FORESTSIDE TOWNHOUSES

TENDER ADDENDUM # 6

JAP Project No: 19066

The following revisions have been made to the drawing set:

S-101B

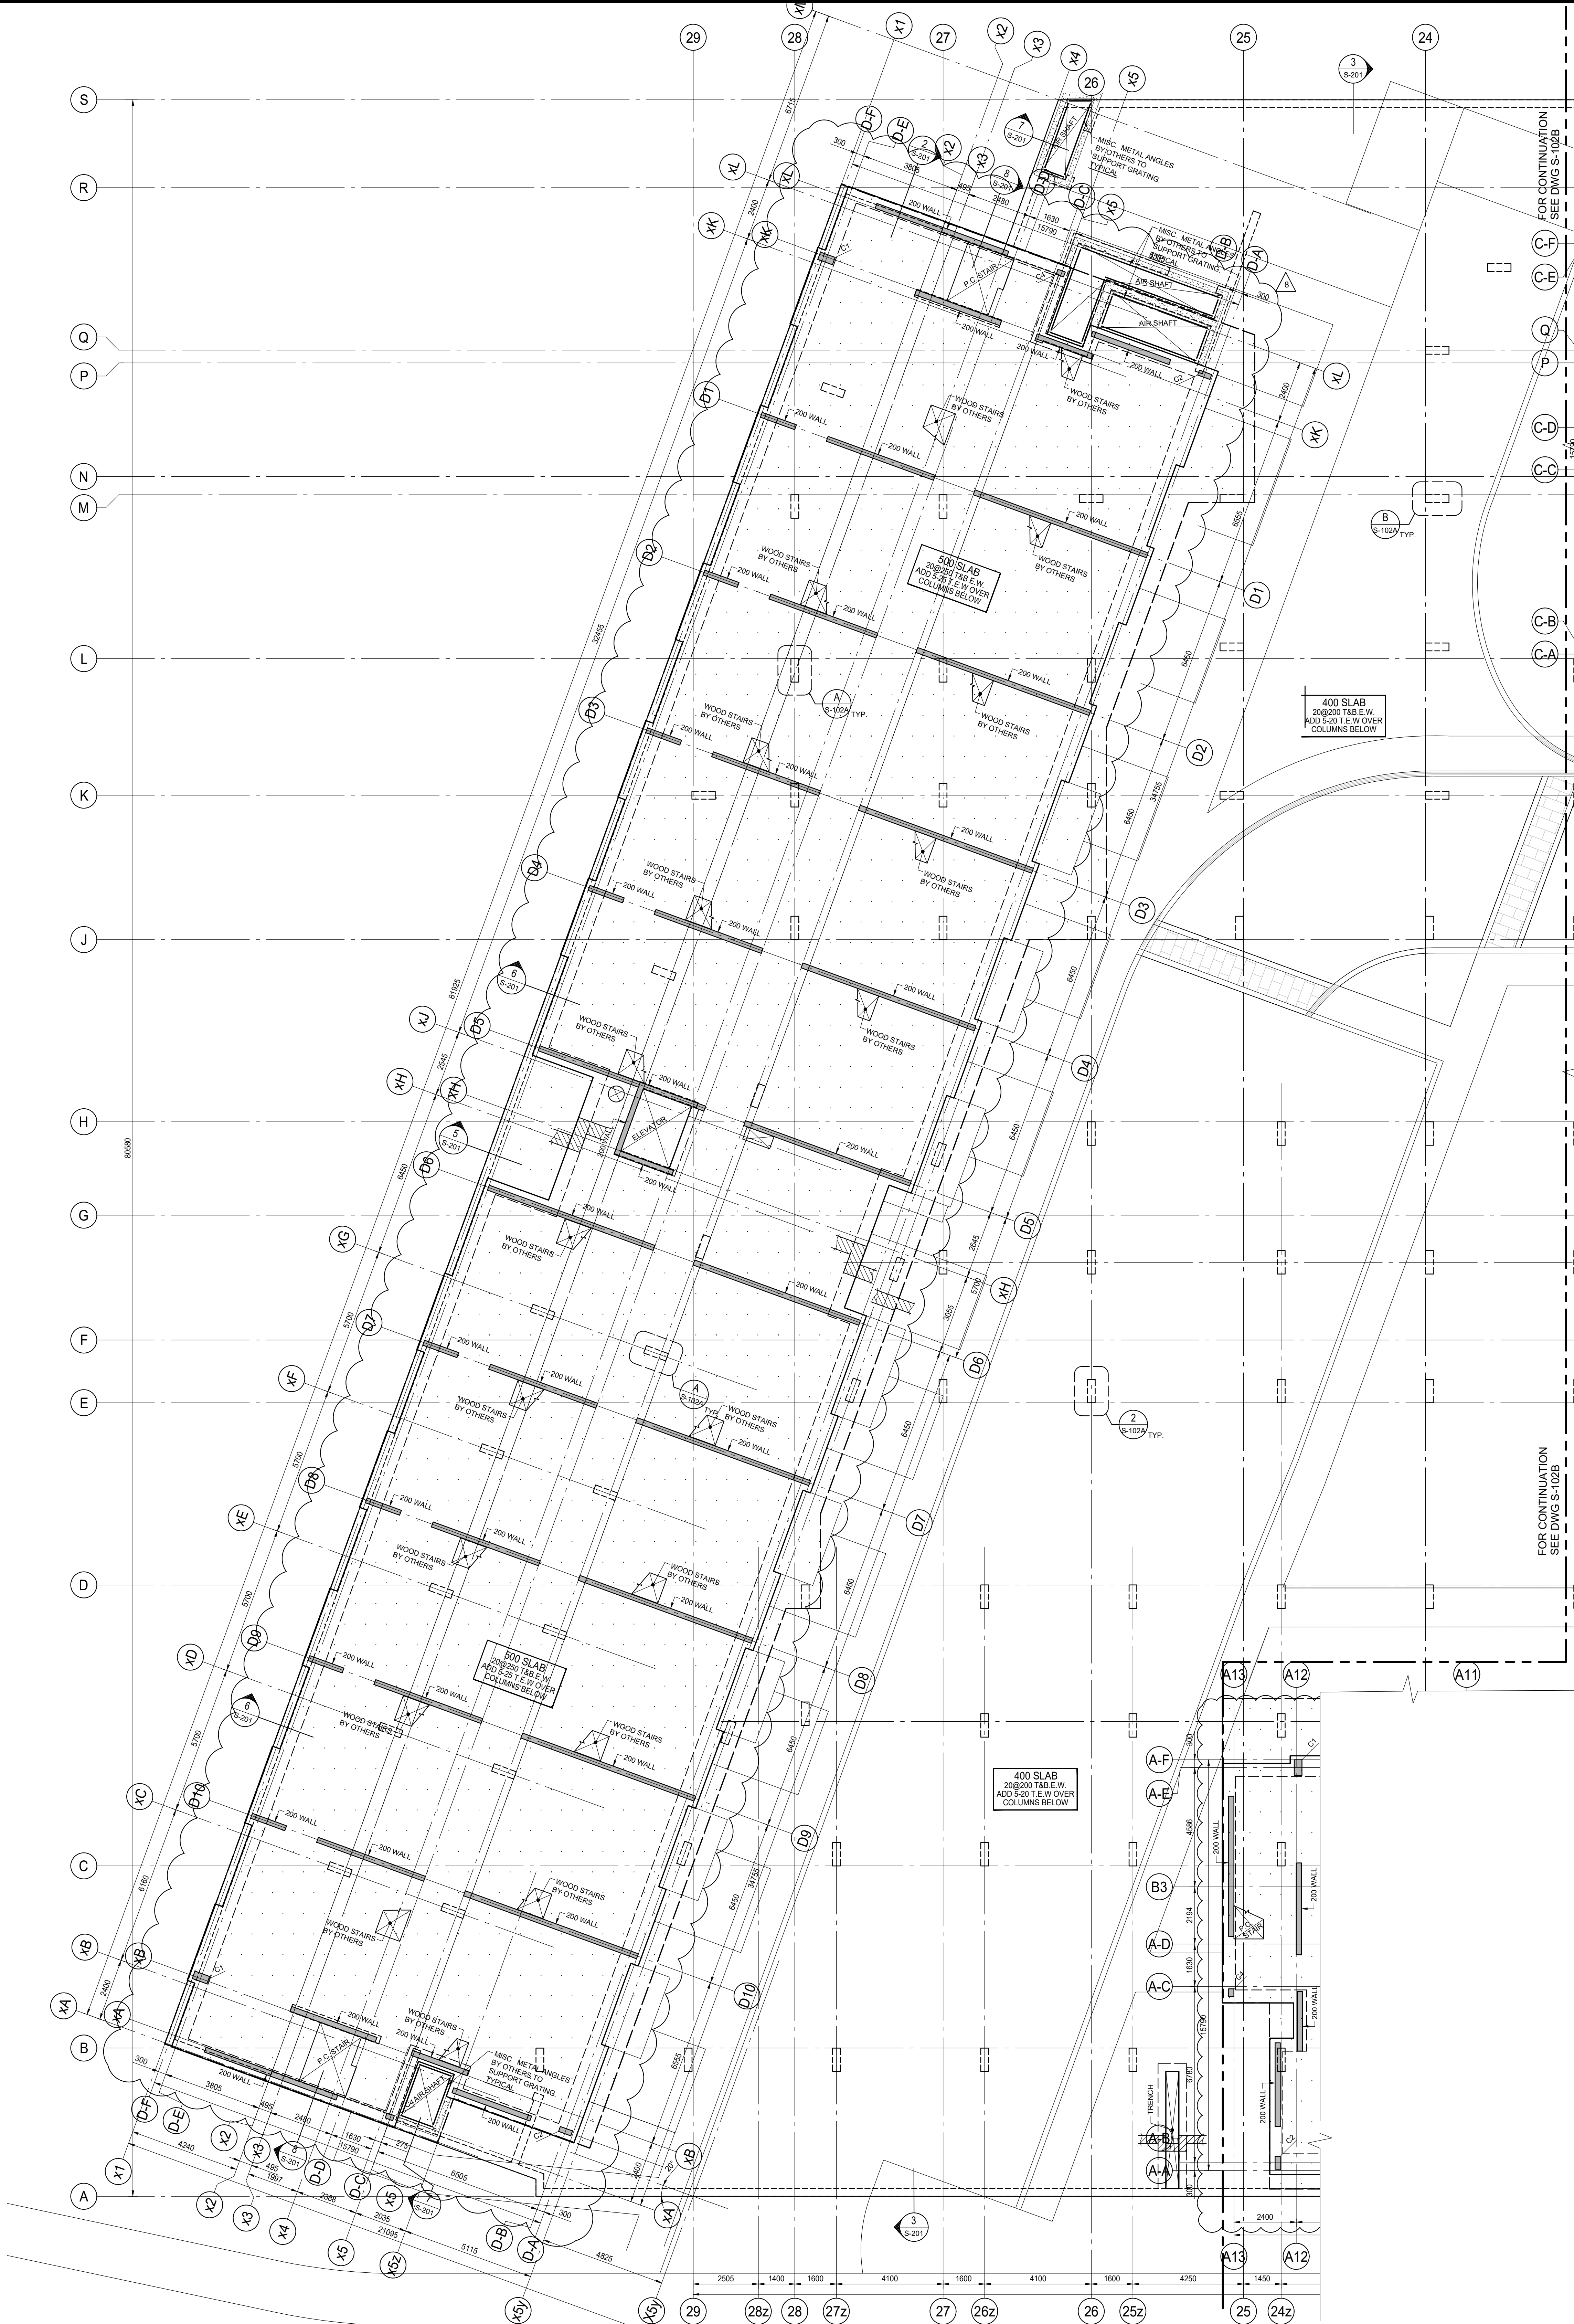
- 1.1 **Refer to Drawing S-101A & B "P1 UNDERGROUND"**
 - a) Updated to match Architectural addendum # 8
 - b) Revised footings as per latest geotechnical information
- 1.2 **Refer to Drawing S-102A & B "GROUND FLOOR"**
 - a) Updated to match Architectural addendum # 8
- 1.3 **Refer to Drawing S-103A & B "2ND FLOOR FRAMING PLAN"**
 - b) Updated to match Architectural addendum # 8
- 1.4 **Refer to Drawing S-104A & B "3rd FLOOR FRAMING PLAN"**
 - c) Updated to match Architectural addendum # 8
- 1.5 **Refer to Drawing S-105A & B "4TH FLOOR FRAMING PLAN"**
 - d) Updated to match Architectural addendum # 8
- 1.6 **Refer to Drawing S-106A & B "ROOF FRAMING PLAN"**
 - e) Updated to match Architectural addendum # 8
- 1.7 **Refer to Drawing S-201 "FOUNDATION SECTIONS"**
 - f) Updated as per latest geotechnical information
